Access Compliance Report

Public Rights-of-Way

Intersection ID: 53292	Main Street: PROSPERITY RIDGE RD	Cross Street: I-485_RA	Location: E
ADA ID: 9DCDD26BC4E2	Ramp Type: Perp	Initial Pass/Fail: Fail	Overall Compliance: No
Codes/Mitigation Info/Possible Solution		Field Measurements/Component Compliance	
Severity Score: 13.75

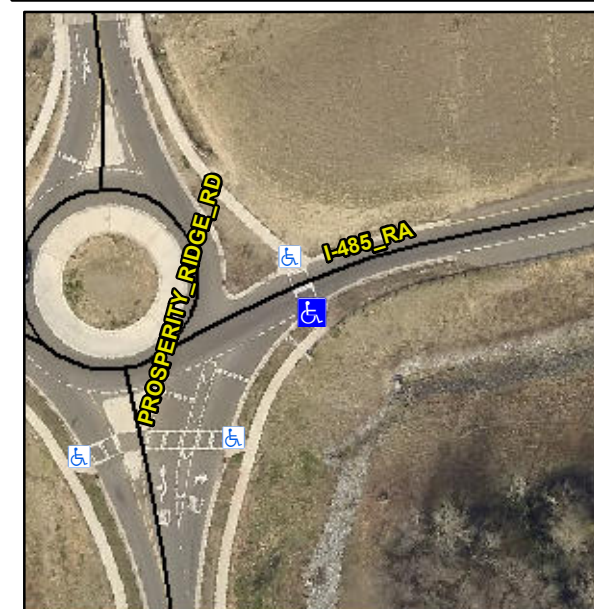
Compliance	Description	Data	Compliance	Description	Data
N/A	Ramp Length (in)	92.5	No	Ramp Slope (%)	9.5
Yes	Ramp Width (in)	48.0	Yes	Ramp XSlope (%)	2.3
N/A	Flare Type LT	N/A	N/A	Flare Type RT	N/A
N/A	Flare Slope LT (%)	N/A	N/A	Flare Slope RT (%)	N/A
N/A	Flare Traversable LT?	N/A	N/A	Flare Traversable RT?	N/A
N/A	Landing Length (in)	N/A	N/A	DWS Provided?	N/A
N/A	Landing Width (in)	N/A	N/A	DWS Contrast?	N/A
N/A	Landing Slope (%)	N/A	N/A	DWS Length (in)	N/A
N/A	Landing X Slope (%)	N/A	N/A	DWS Full Width?	N/A
N/A	Landing Curb? (Y/N)	N/A	N/A	DWS Offset (in)	N/A
N/A	Shared Landing?	N/A			
N/A	Gutter Ponding?	N/A	N/A	Gutter Slope (%)	N/A
N/A	Gutter Lip Ht (in)	N/A	N/A	Gutter X Slope (%)	N/A
N/A	Painted X Walk1?	Yes	N/A	Painted X Walk2?	N/A
	X Walk 1 Direction	To N		X Walk 2 Direction	N/A
N/A	X Walk 1 Width (in)	104.0	N/A	X Walk 2 Width (in)	N/A
	X Walk 1 Slope (%)	3.1		X Walk 2 Slope (%)	N/A
	X Walk 1 X Slope (%)	4.4		X Walk 2 X Slope (%)	N/A

Remove & Replace Entire Ramp.
